From: Jeff Setera [jsetera@sandis.net]
Sent: Monday, August 29, 2011 10:37 AM
To: Wickham, Jerry, Env. Health
Cc: Miller, Charles GSA - Technical Service Department; mkuykendall@sandis.net; 'Logan Medeiros'; 'Peter Langtry'; 'Paul Beamer'; 611021@sandis.net; 'Nathan Allen'
Subject: 611021 - Ashland Revised Soil Sampling Plan
Attachments: Ashland Youth Center - Soil Sampling Plan 082911.pdf

From: Wickham, Jerry, Env. Health
Sent: Monday, August 29, 2011 11:33 AM
To: Jeff Setera
Cc: Miller, Charles GSA - Technical Service Department; mkuykendall@sandis.net; 'Logan Medeiros'; 'Peter Langtry'; 'Paul Beamer'; 611021@sandis.net; 'Nathan Allen'
Subject: RE: 611021 - Ashland Revised Soil Sampling Plan

I have reviewed the Revised Soil Sampling Plan consisting of a Revised Sampling Location Map and the text referenced below for case RO0212. The proposed sampling is acceptable with the same two conditions listed below that were provided in our previous comments:

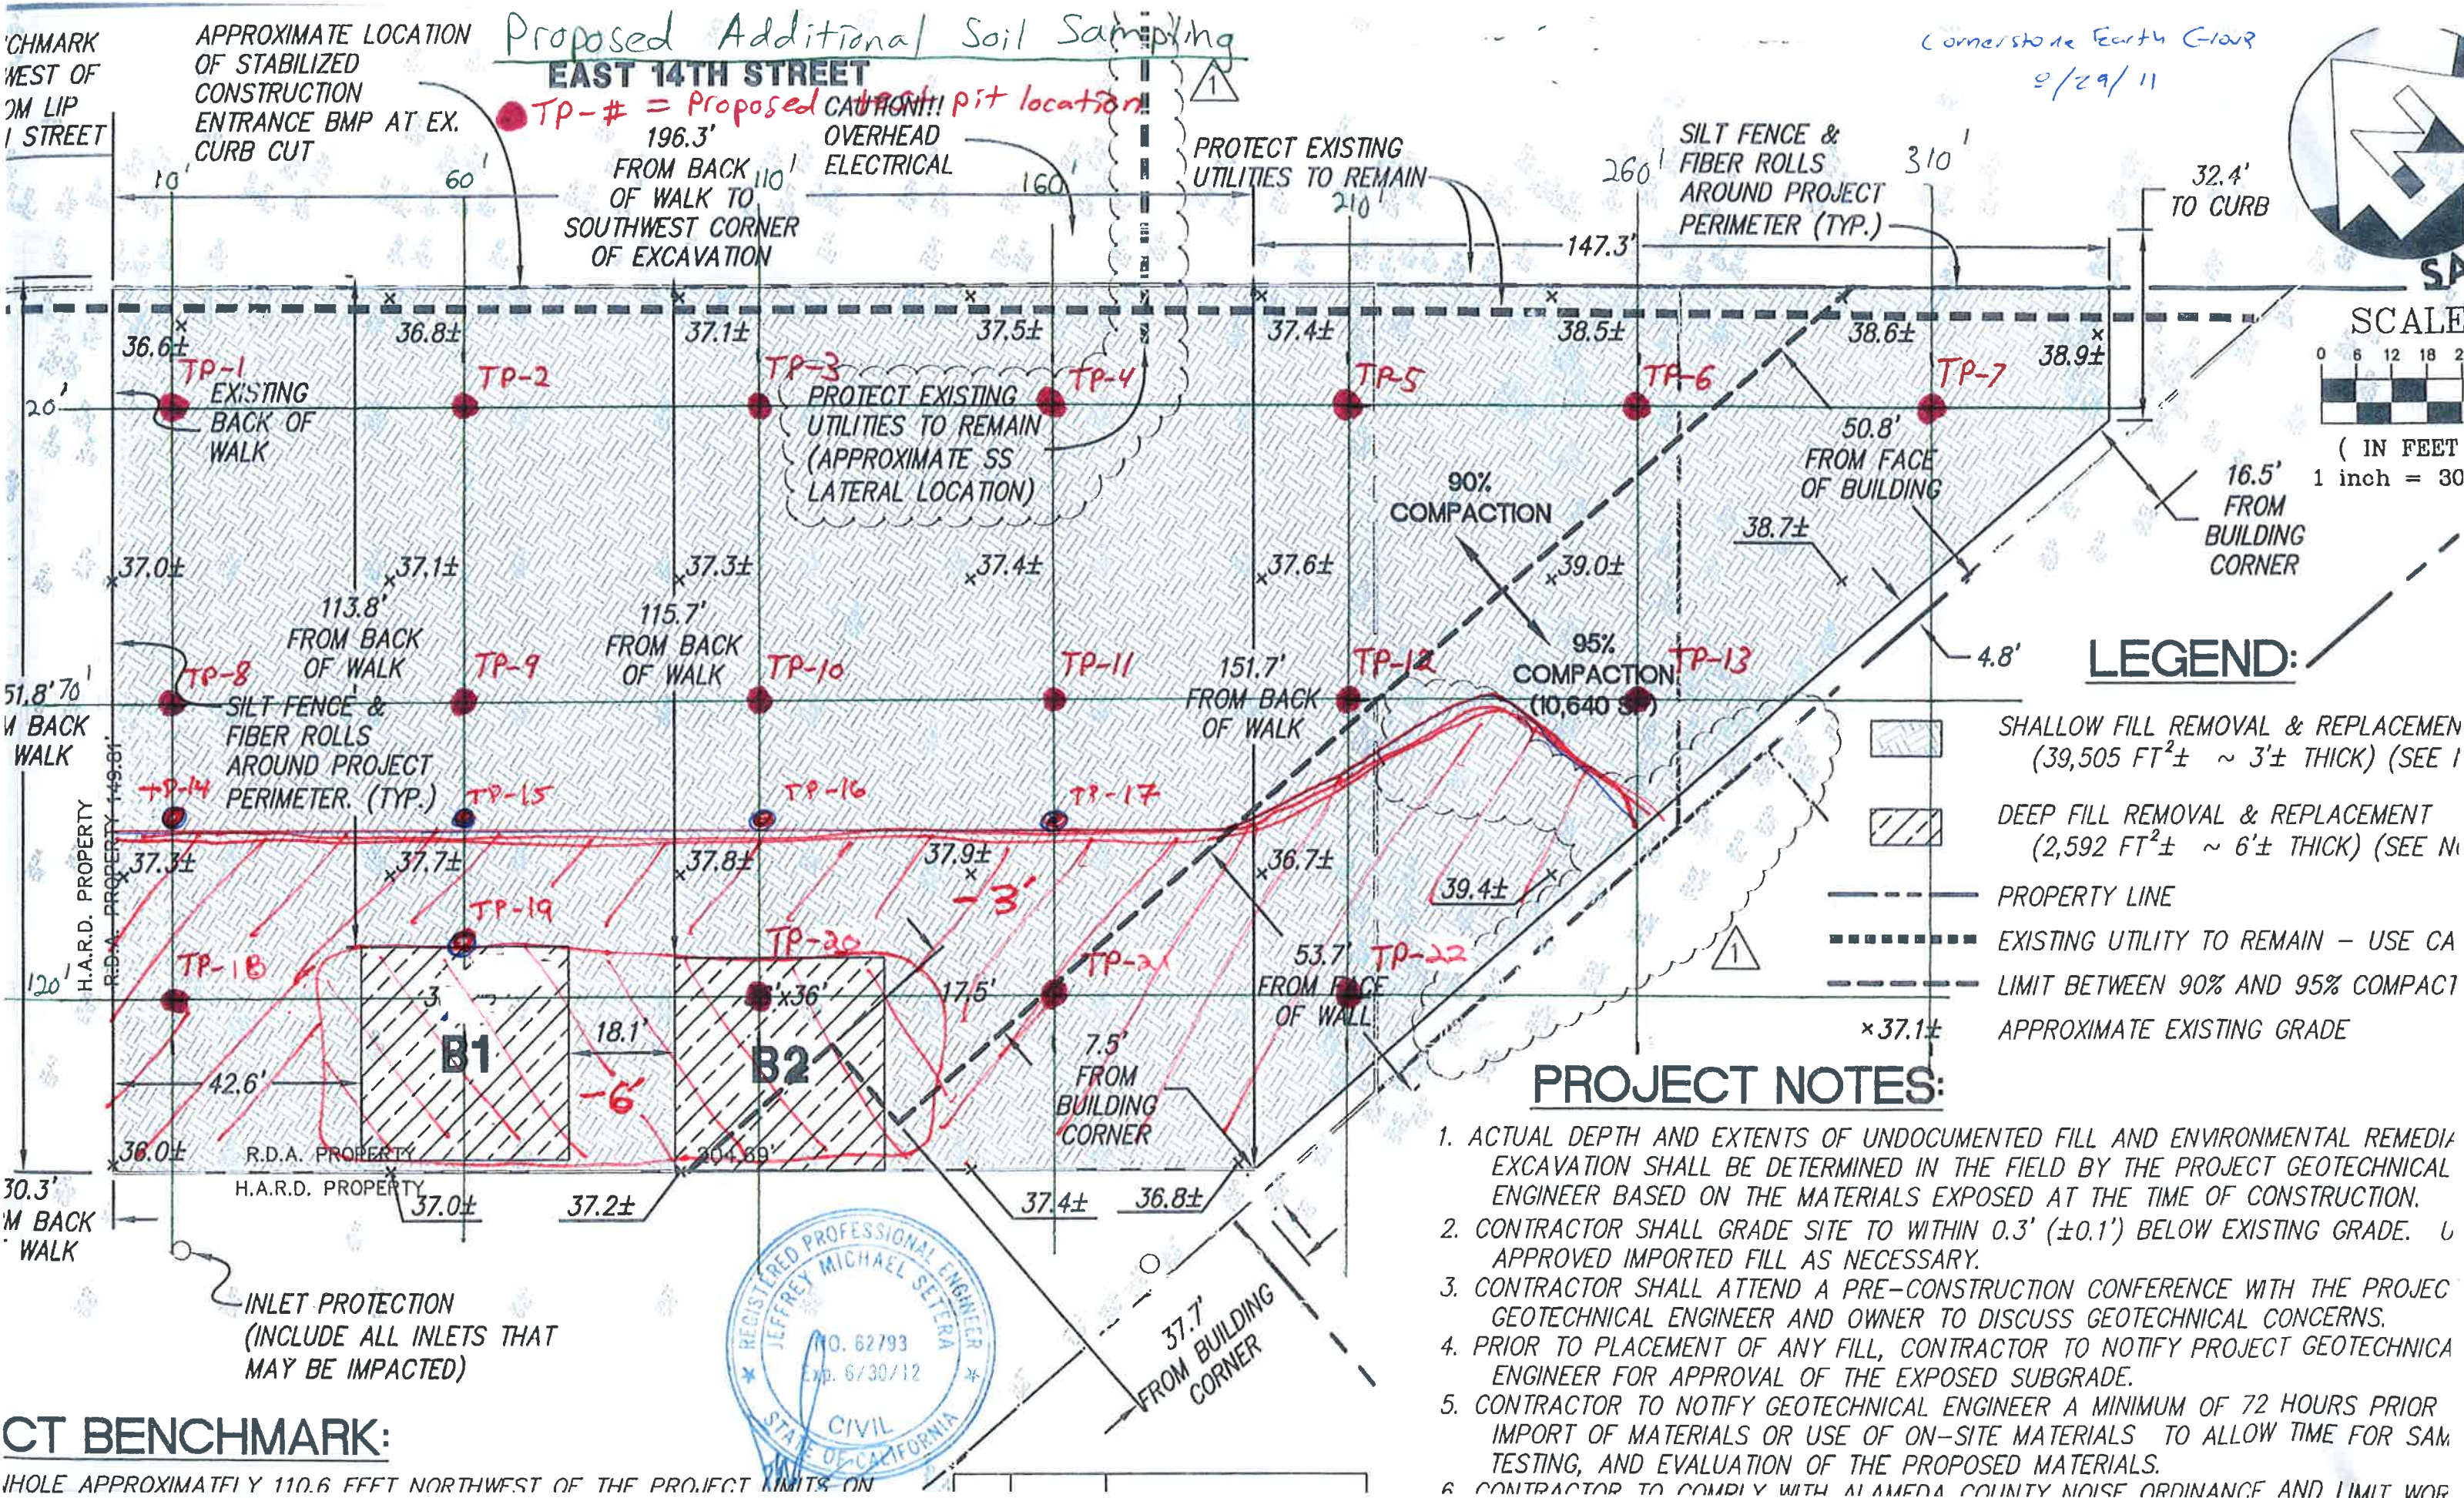
Here is the proposed soil sampling plan for August 30. The locations are shown on the attached site map. The goal of the sampling is to delineate the vertical and lateral extent of contaminants of concern in on-site soil and to provide information needed for landfill waste profiling.

Test Pits TP-1 through TP-17

Test Pits TP-18, TP-29, TP-21 and TP-22 (located within -3 foot cut)

Test Pit TP-20 (located within -6 foot cut area/former pit B2)

- 1) If visual staining, odor, elevated PID readings, or other obvious signs of contamination are observed in a test pit, the fixed sample intervals will be adjusted or additional soil samples will be collected as necessary to characterize the contamination.
- 2) The conditions in each test pit will be logged by a qualified engineer or geologist.
